**NSLPP MEETING HELD ON 06/08/2025**

**ADDRESS/WARD:** 17 Bridge End, Wollstonecraft

**APPLICATION No:** DA273/24

**PROPOSAL:** Demolition of all structures and the replacement of three residential apartment buildings containing a total of 12 dwellings with a single residential flat building containing 22 Units

**Figure 5: Height plane diagram showing the arse of the proposed building that exceed the maximum building height.**

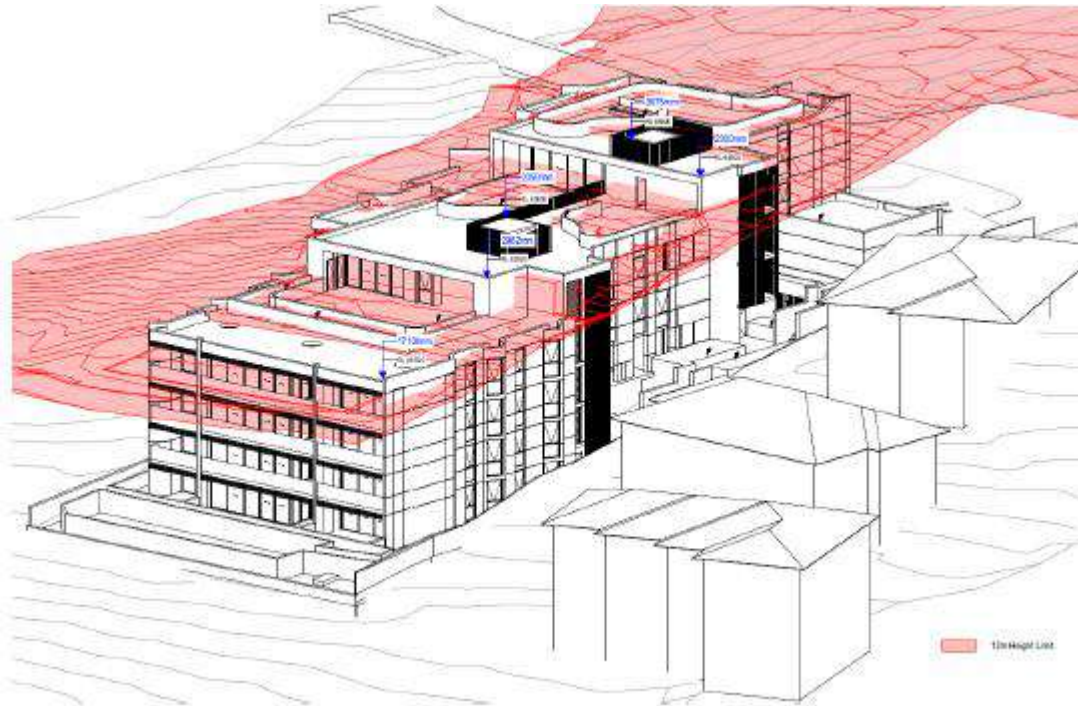
The location and extent of the non-compliance is provided in the height plan diagram below:

*The planning grounds established by the Applicant are not considered sufficient to justify contravening the development standard. The amenity impacts associated with the non-compliance have not been fully considered in terms of view loss and overshadowing to adjoining properties. The scale and size of the building will be inconsistent consistent with the future and desired character of the area. This effect is increased by the proposals failure to adequately address site and landscape area controls discussed in the DCP compliance section of this report. While an argument could be made to rely on the low and mid rise housing reforms for building height, it is necessary to consider other controls outside these reforms to assess the appropriateness of development.*

**Figure 6: Section of building showing the 12m maximum height limit and proposed building outline**

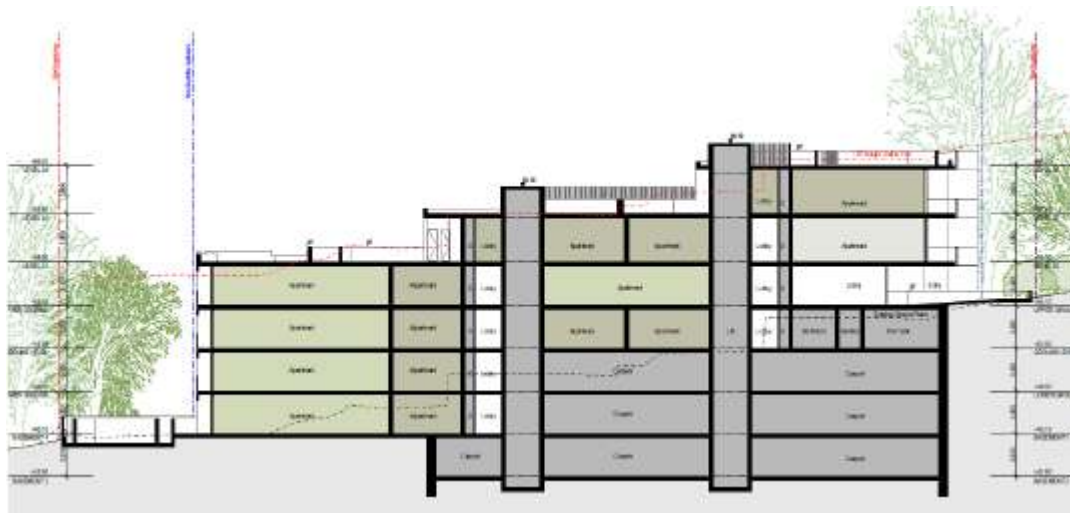
Any variation to a statutory control can only be considered under Clause 4.6 – Exceptions to Development Standards of the NSLEP. An assessment of the proposed height against the survey plan levels was conducted to indicate the Applicant's calculations are generally accurate.

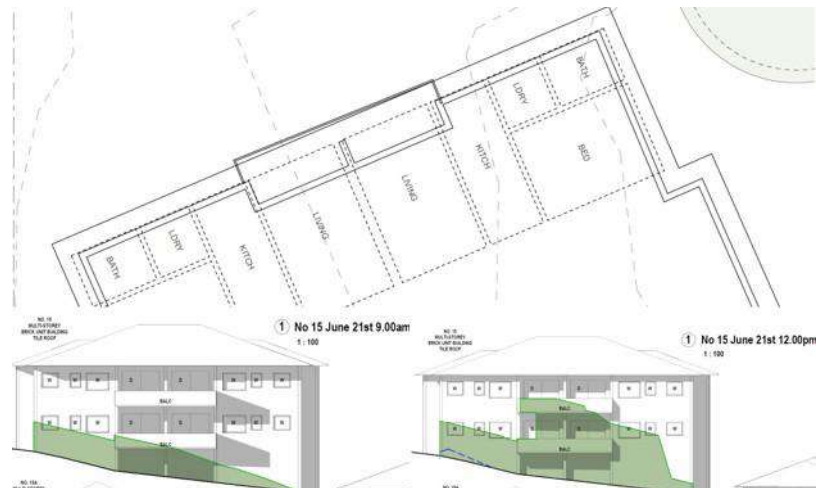
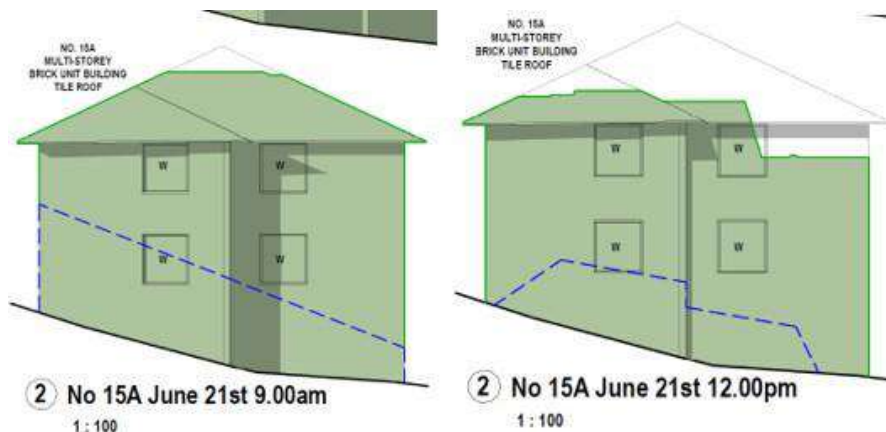
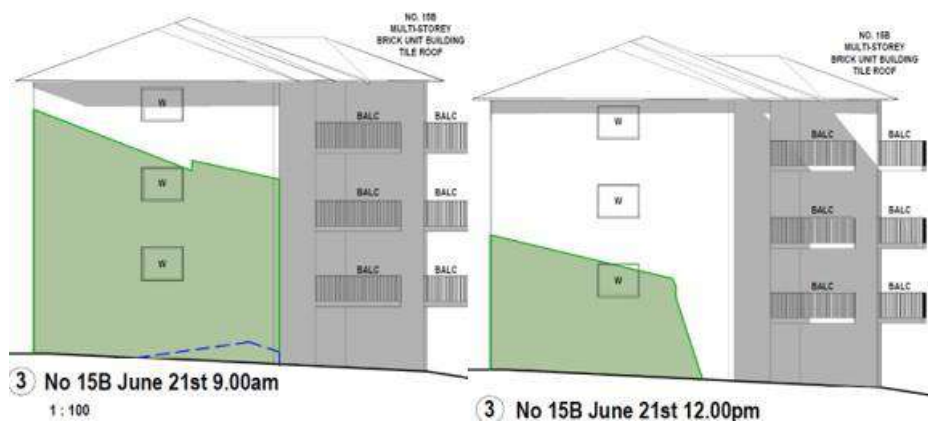
*15 Bridge End (Elevation 1) will receive a minimum of 2 hours solar access between 9 AM and 12 AM at 21 June. As shown in the figure overleaf, the layout of unit 15 has a bathroom, laundry and kitchen along with a balcony and living room on the façade where shadow is cast. Of these areas, only the living room and balcony can be considered as either habitable space or as recreational space. The living room and balcony of 15 Bridge End will receive at least 2 hours solar access between 9am and 12 noon on 21 June which complies with daylight access standards and is therefore acceptable.*

*15A Bridge End (Elevation 2) has no shadowing to its balconies, with shadow contained to the side elevation. Therefore, living areas and private open space is not overshadowed at any time and daylight access is maintained.*

*15B Bridge End (Elevation 3) has no shadowing to its balconies, with shadow contained to the side elevation between 9AM and 12 noon. Therefore, living areas and private open space is not overshadowed at any time and daylight access is maintained.*

<i>(c) to maintain solar access to existing dwellings, public reserves and streets, and to promote solar access for future development,</i>	<p>Revised shadow diagrams were not submitted with the amended plans; therefore, an assessment cannot be carried out.</p> <p>The shadow diagrams submitted with the original application demonstrated that the proposal would have an adverse impact on the private open spaces of no.15 Bridge End.</p> <p>The consent authority cannot be satisfied that the proposal satisfies this objective.</p>
